# KTI Networks Important Notice

KGD-600

Ver.1.24 or earlier

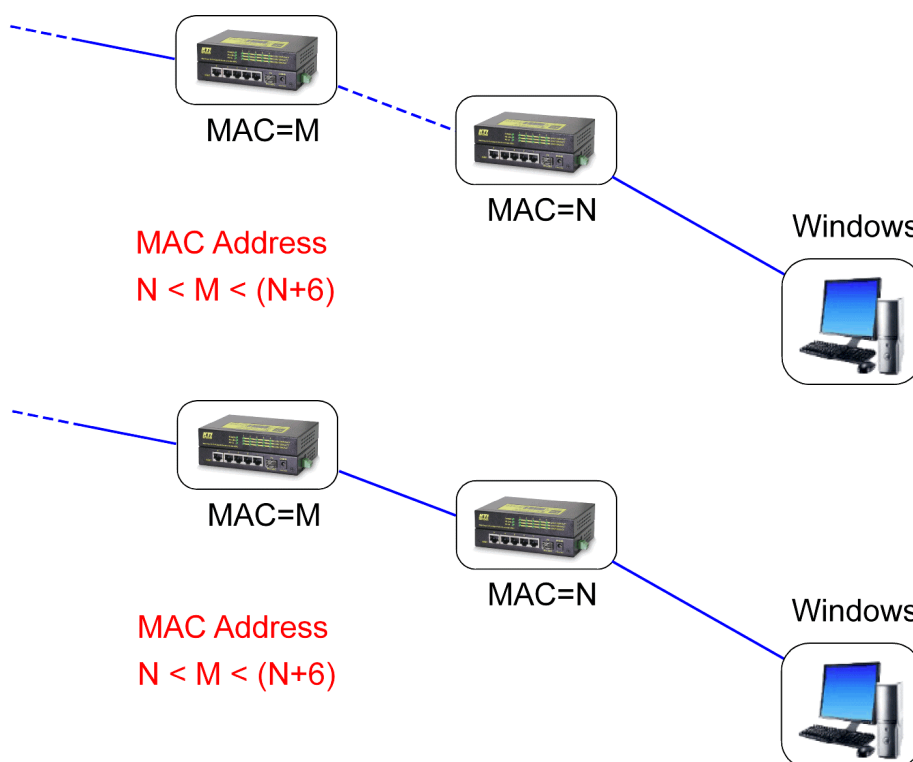
As two scenarios shown below, the Windows PC is unable to manage the Switch M via web browser or ping the Switch M through the Switch N if the Mac address M is within the range of N and N+6.

In both scenarios, the packet switching function on the Switch M and Switch N are with no problem but only management function.

Update the firmware of the Switch N with firmware **Ver.1.25**.
